RotorSport UK Ltd Service Bulletin (Permit)

Title: Cavalon fuel-tank outlet (rework)		
SB No.: 101 Iss1	Related documents MC No: MC-325 CCAR No.: None	Compliance Category: OPTIONAL or RECOMMENDED or MANDATORY
Applicability		
Aircraft type & model: Cavalon	Aircraft serial Nos. affected: RSUK/CVLN/001 to 017	
This form is the response from RotorSport UK Ltd either against a problem found in the product in service requiring a containment or rectification action, or as service information for aircraft modification incorporation. For help, contact RotorSport on 44(0)1588 650769, or email info@rotorsport.org.		
<u>Reason and overview of the Service Bulletin (cause of problem if known)</u>		
<p>There have been reports of a strong smell of fuel around some Cavalon aircraft when hangered, and it has been found that fuel has been seeping from the outlet at the base of the primary (left) fuel tank. Further, it has been found that this seepage is due to a tolerance issue during manufacture of the fuel tanks.</p> <p>A simple rework process has been developed to enable rectification of affected aircraft under this service bulletin SB-101</p>

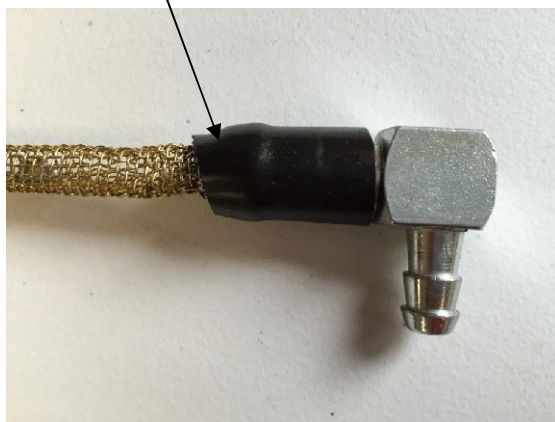
3. Using a syphon tube then the water/fuel drain completely empty the fuel tanks
4. Inspect the cross-over tube hoses. If fuel has been weeping for some time the tube surface may have degraded and the tube should be replaced.
5. Disconnect the fuel hose from the fuel tank outlet fitting and pull the fitting out of the bushing.
6. Remove the bushing and inspect. If undamaged it may be re-used, if in doubt replace.
7. Inspect the hole in the fuel tank. This must be free of burrs or strands of polythene and the hole must be no bigger in diameter than 15.5mm at any point in its circumference. If satisfactory refit the bushing
8. Clean the fitting then push over the rubber sleeve RSD4851/23 (with a little light oil or grease for lubrication) until it abuts the square body. Trim off any excess so that the rubber is flush with the end of the fitting.

9. Re-attach the fitting to the fuel hose with a new side crimp.
10. Apply a smear of light oil or grease to the sleeve and push the fitting back into the fuel-tank bushing until fully home and secure.
11. Refill the fuel tank with petrol. (Use of a water-trapping funnel is highly recommended at all times)
12. If no leaks evident the refit the inspection cover
